From: Detterman, Mark, Env. Health
Sent: Wednesday, February 03, 2016 5:59 PM
To: 'Kyle S. Flory'
Cc: Roe, Dilan, Env. Health; 'Rachel Green'; Morgan Jones
Subject: RE: Anton Evolve - Proposed Additional Grab Groundwater Sample Locations

From: Kyle S. Flory [<mailto:kflory@pesenv.com>]
Sent: Wednesday, February 03, 2016 3:15 PM
To: Detterman, Mark, Env. Health
Cc: Roe, Dilan, Env. Health; 'Rachel Green'; Morgan Jones
Subject: Anton Evolve - Proposed Additional Grab Groundwater Sample Locations

Site Plan Showing Proposed Soil Vapor, Soil, and Grab Groundwater Sample Locations
 Work Plan for Supplemental Pre-Construction Subsurface Investigation
 6701, 6705, and 6707 Shellmound Street
 Emeryville, California

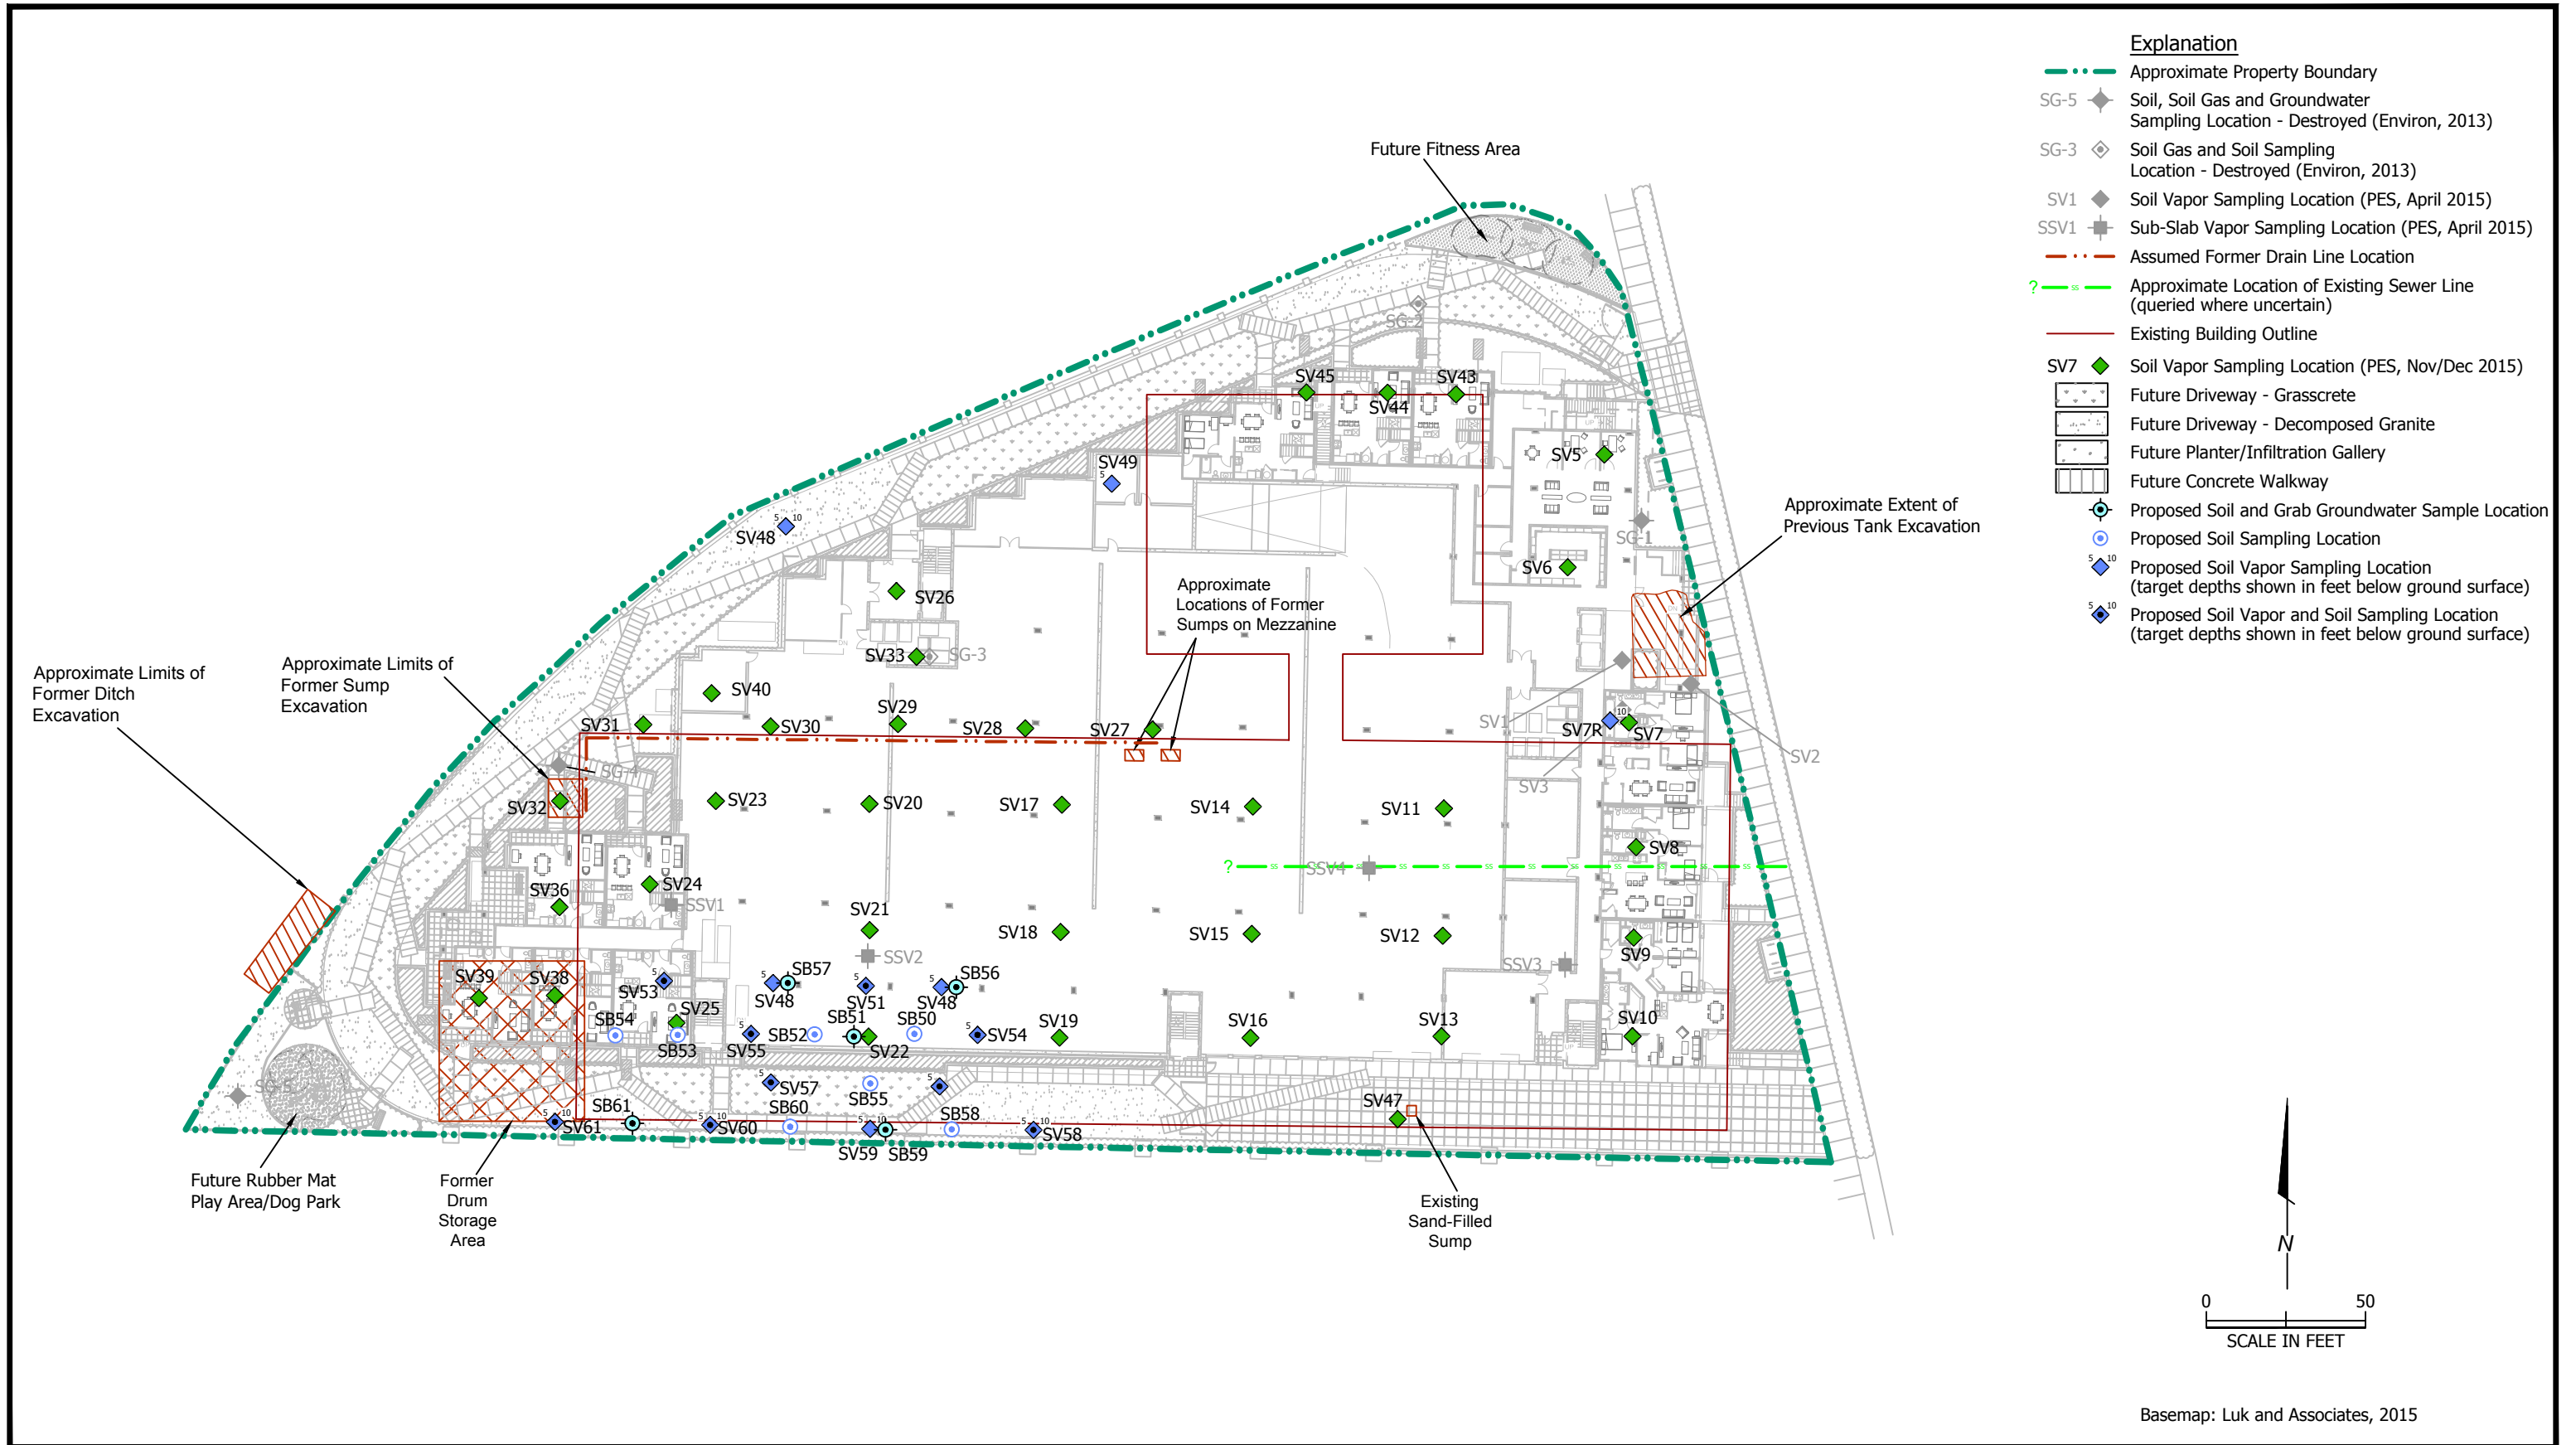
The initial intent of collecting a grab groundwater sample was to determine if the soil vapor indications of vinyl chloride (VC) contamination had impacted groundwater beneath the site. It has. I note that the RWQCB ESL for VC in non-drinking water (which I presume this to be) is 1.8 ug/l and that 1.6 ug/l is thus very close to the groundwater ESL. I also note that this specific groundwater ESL was defined due to the risk of vapor intrusion from VC in non-drinking water (which ESLs assume to be at least 10 feet below grade on a continuing basis). I counted two additional locations for grab groundwater sampling in the NE and NW directions from SB51 / SV22 location presumably to look for upgradient or lateral concentrations of VC in groundwater, which is reasonable direction from an undefined source. However, the other real concern at the site, and potentially downgradient at the adjacent site, is the risk of vapor intrusion from groundwater if the VC is not defined downgradient. At a minimum it appears reasonable to collect grab groundwater samples in the presumed downgradient direction (SW) and laterally to the SE (from SB51 / SV22) to quickly define the extent of VC to values further below the ESL (generally identified goal for site) due to the near similarity of the detected concentration with the ESL. Other step out bores may also be appropriate depending on the results of these added bore / grab groundwater results.
